5 November 2018

Wenona School - SSD6952 (MOD2)

I refer to our meeting on Friday 26 October 2018 that was also attended by your Andrew Beattie and Kate Tudehope of Ethos Urban, to discuss SSD6952 (MOD2). This letter responds to your request at the meeting for further information.

Appendix H

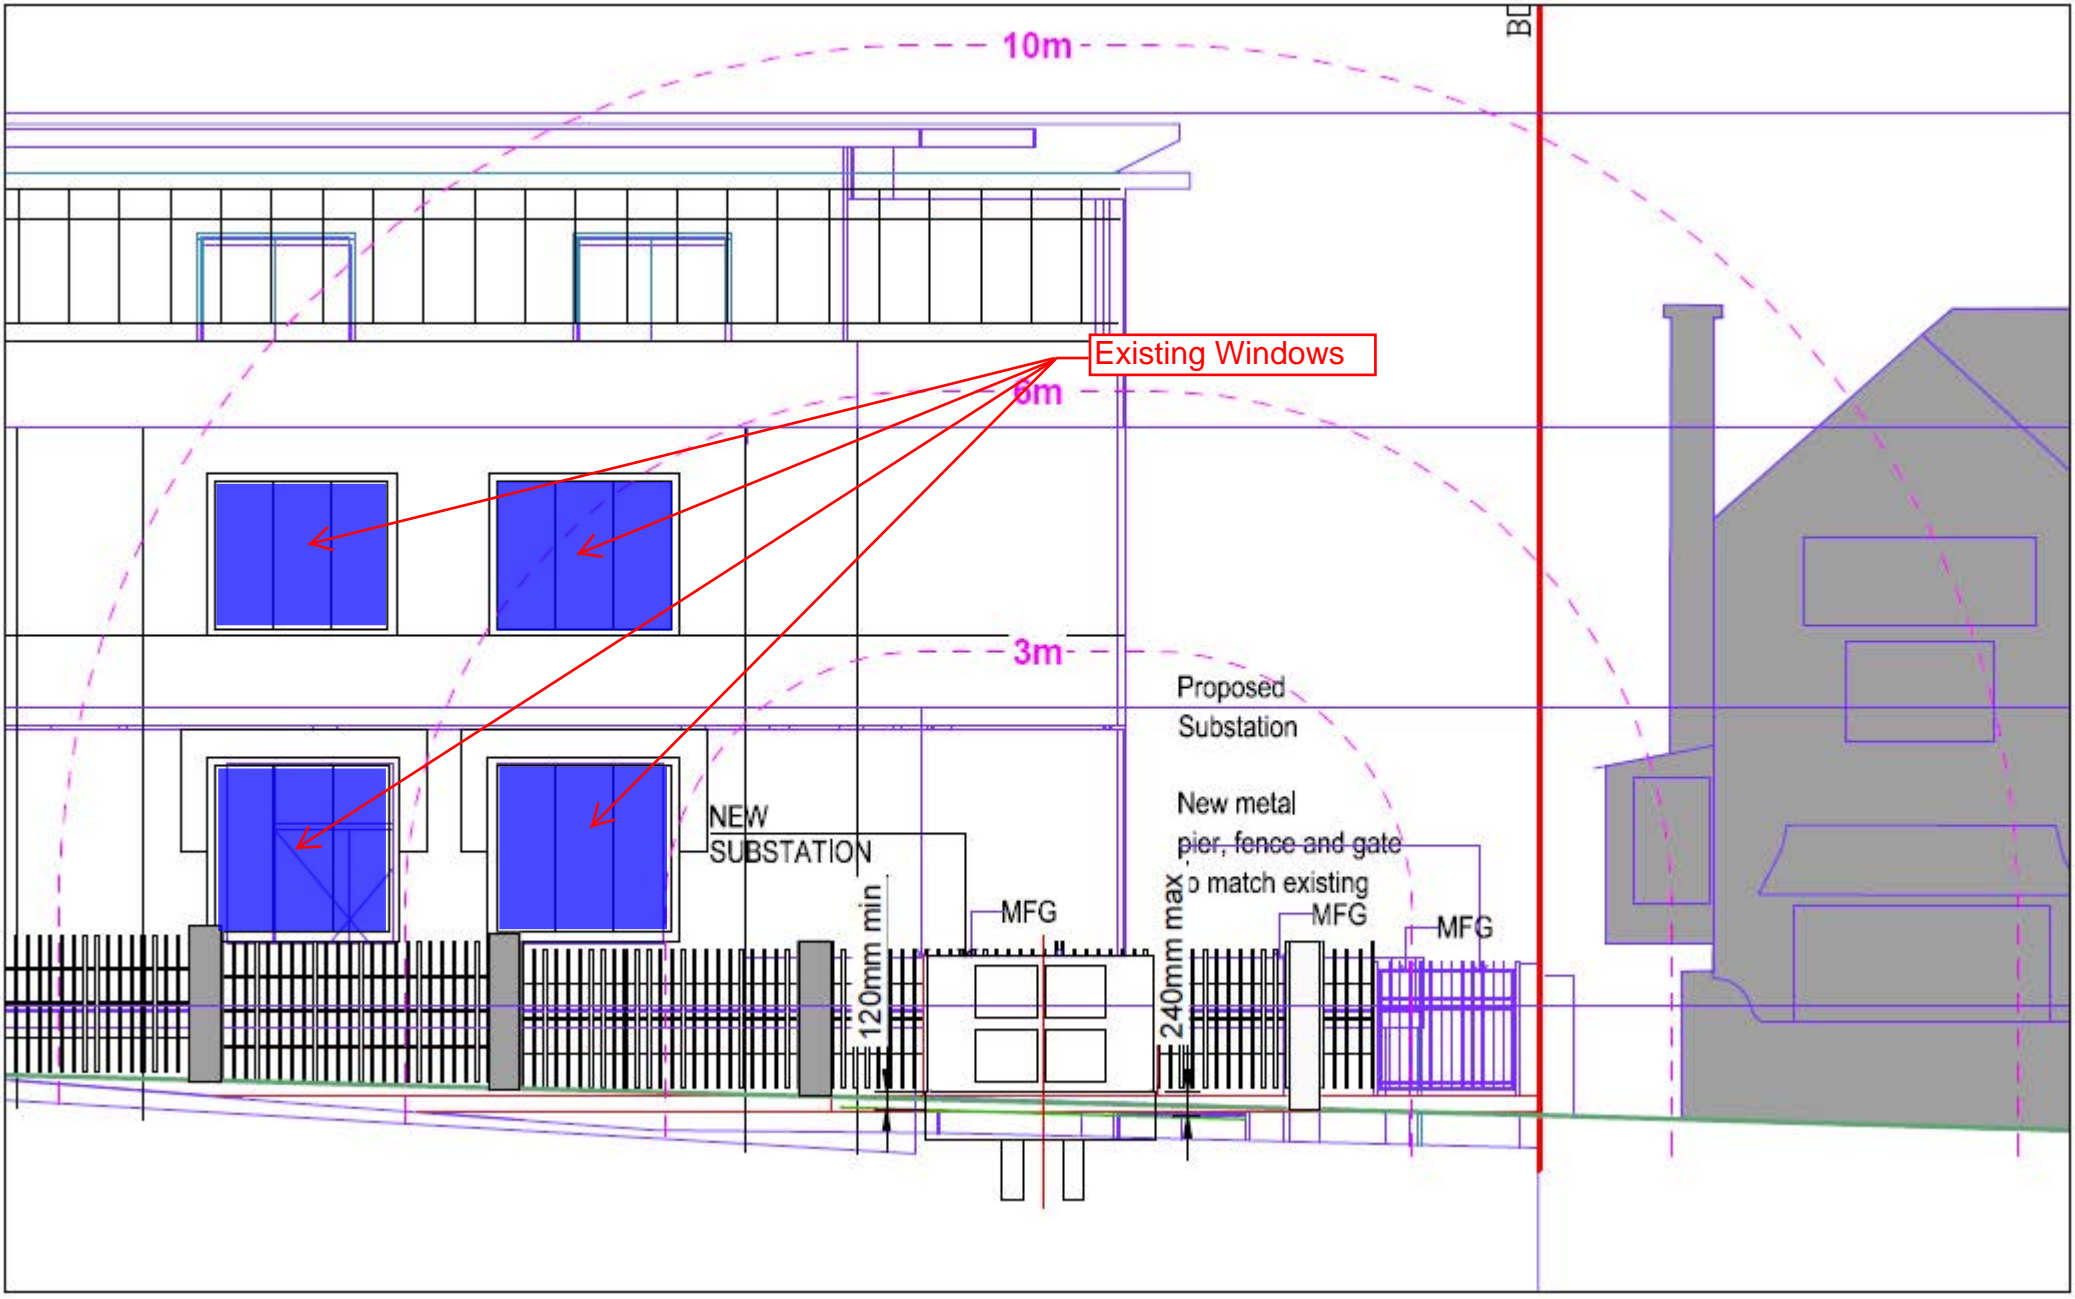
Request No. 7

The DEP acknowledges our advice that the substation cannot be moved northwards because of the existence of belowground structures which would conflict with Ausgrid's requirements. The DEP notes that we have also advised that the substation could not be positioned further to the north as this would position the substation within the blast zone of the substation. In this regard the DEP notes that Ausgrid Standard NW000-S008 states that windows (openable or otherwise) are not permitted within 3 metres of the substation unless they are sheltered by non-ignitable blast resisting barrier. Clarification is sought about whether this is also a factor in the need to locate the substation at the southern end of the site away from the existing nearby windows.

See **Appendix H** for an excerpt from the certified substation design which shows the location of existing windows in the western façade of the existing school building. The excerpt also shows the extent of the 3m exclusion zone, which in the certified design is immediately adjacent to these windows. While Ausgrid will not place the substation over the existing subterranean structure for the reasons we have explained, if it was able to do this thereby positioning the substation further north away from the tree then this would require construction of a non-ignitable, blast-proof barrier to protect these windows. This would have an unacceptable impact on the amenity (natural light and outlook) of the spaces within the building and also on the streetscape. Additionally, such a barrier would require a foundation which would foul the same in-ground structure which caused the need for the relocation of the substation in the first place.
